DATE: December 3, 2012
TO: All Prospective Bidders
SUBJECT: **Addendum No. 3**
Equipment / Vehicle Wash Facility
Contract No. PW 12-30631, Project No. 81134

FLASHING DETAIL (3/A4.0)
 EQUIPMENT/ VEHICLE WASH FACILITY
 EL DORADO COUNTY DEPARTMENT
 OF TRANSPORTATION
 2441 HEADINGTON RD., PLACERVILLE, CA 95667

REVISION NO.	ADDENDUM NO.3
JOB NO. 2957	DRAWING NO. R-2 (1/54.1)
DATE 11/30/2012	
DRAWN BY	
CHECKED

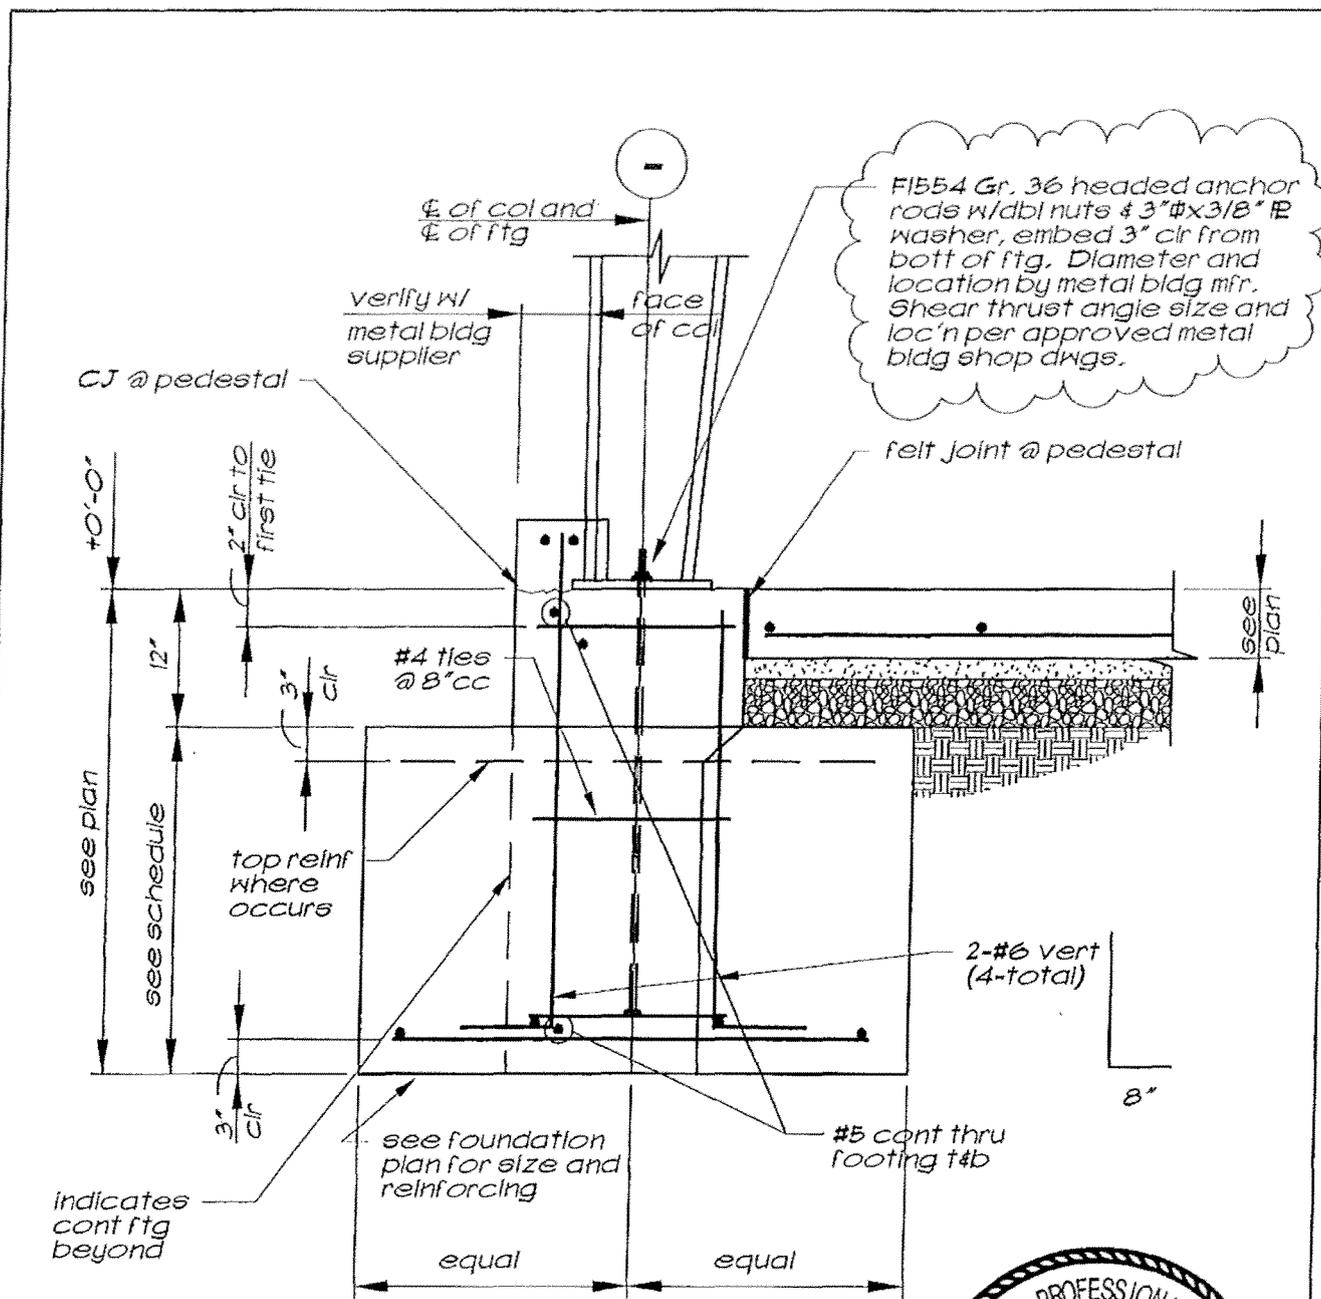
3.07	Plan sheet S4.1	<p>The following revision is a result of a question about the anchor bolts:</p> <p>Replace Detail 1/S4.1 with revised Detail 1/S4.1 attached to this addendum as Exhibit R-2.</p> <p>Replace Detail 3/S4.1.0 with revised Detail 3/S4.1 attached to this addendum as Exhibit R-3.</p>

Typical Edge Frame Column
